ADDENDUM NO. 5

RFQ 72779

The following changes and/or additions shall be made to the original Invitation for Bid No. RFQ 72779, Construction of the Ashburn Senior Center. Please acknowledge receipt of this addendum by signing and returning with your bid.

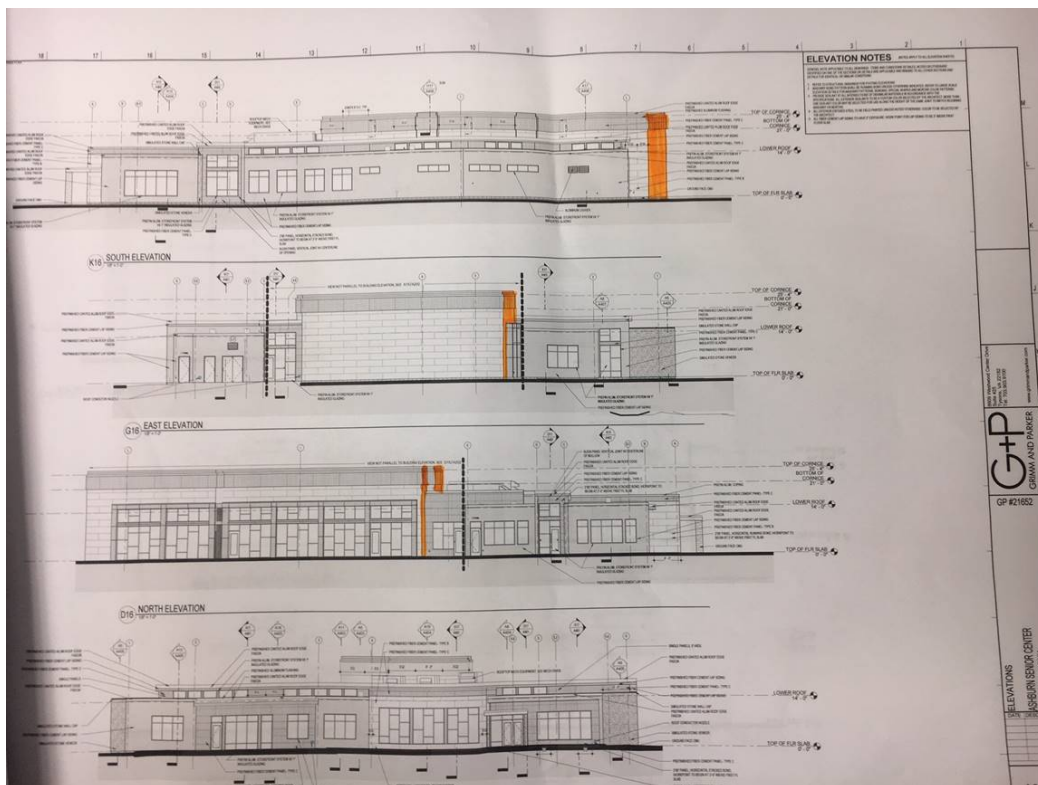
**Question 8. On Page A201 (reference photo below) I have highlighted 3 areas on Detail K16, G16, and D16, that have a callout pattern that does not match any of the other callout patterns on the building elevations, and there is no description of these materials to be provided. Can you please clarify what the materials are to be used in these areas?**

**Answer 8. The highlighted areas on Details K16, G16, and D16 are all Prefinished Fiber Cement Panel Type B shown at an extreme angle.**

**The highlighted area of K16 is shown orthogonal in Elevation A15/A202.**

**The highlighted area of G16 is shown orthogonal in Elevation D15/A202.**

**The highlighted area of D16 is shown orthogonal in Building Section K8/A402.**
